DREO PTE. LTD.

Ref: FCC Class II Permissive change for FCC ID:2BPBC-HPA033

This is to request a Class II Permissive change for FCC ID: 2BPBC-HPA033 originally granted on 2025-09-18 (date).

Buttons
Original

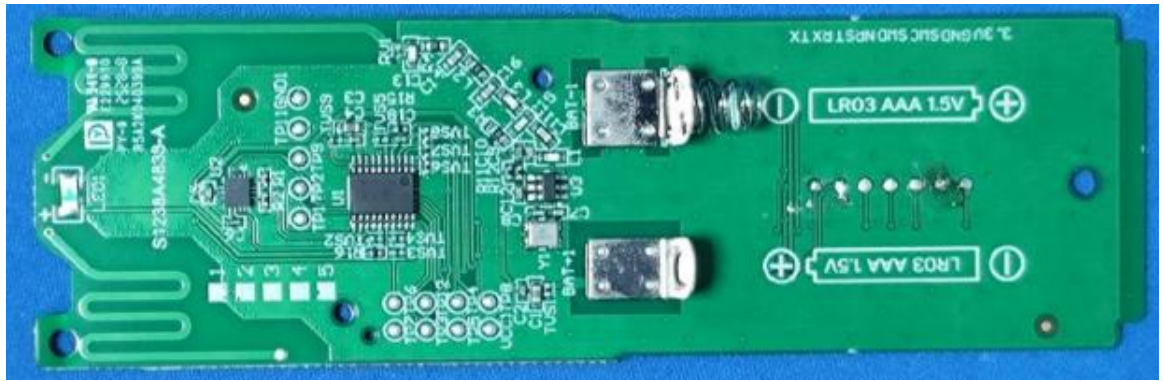
updated the buttons and electron component.The change under this application as below:

original	New
Model No.:	DR-HPA033	DR-HPA033A,

Differences between RF remote controller (gyroscope removed) and original 033 remote controller:

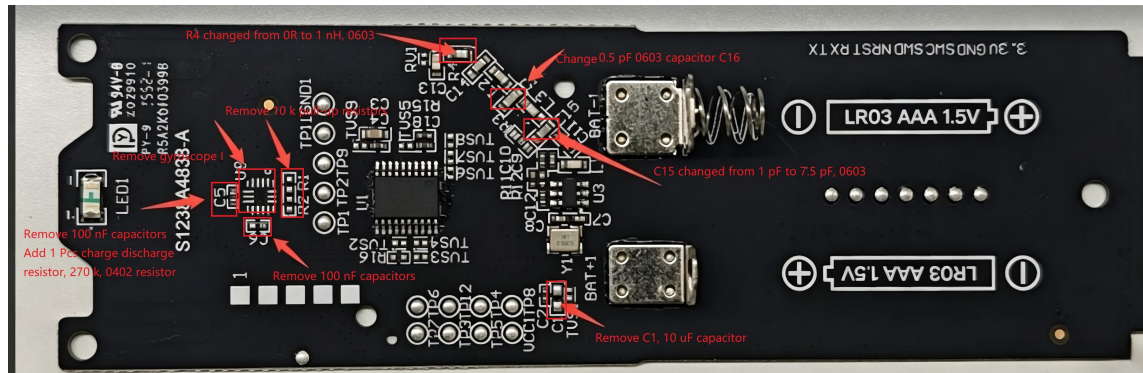
- ① Remove gyroscope I
- ② Remove gyroscope power supply decoupling capacitors, 2 Pcs of 100 nF capacitors, 2 Pcs of 10 k pull-up resistors; remove C1, 10 uF capacitor
- ④ Add 1 Pcs charge discharge resistor, 1 PCS 270 k, 0402 resistor
- ⑤ Change 0.5 pF 0603 capacitor C16
- ⑥ R4 changed from 0R to 1 nH, 0603
- ⑦ C15 changed from 1 pF to 7.5 pF, 0603
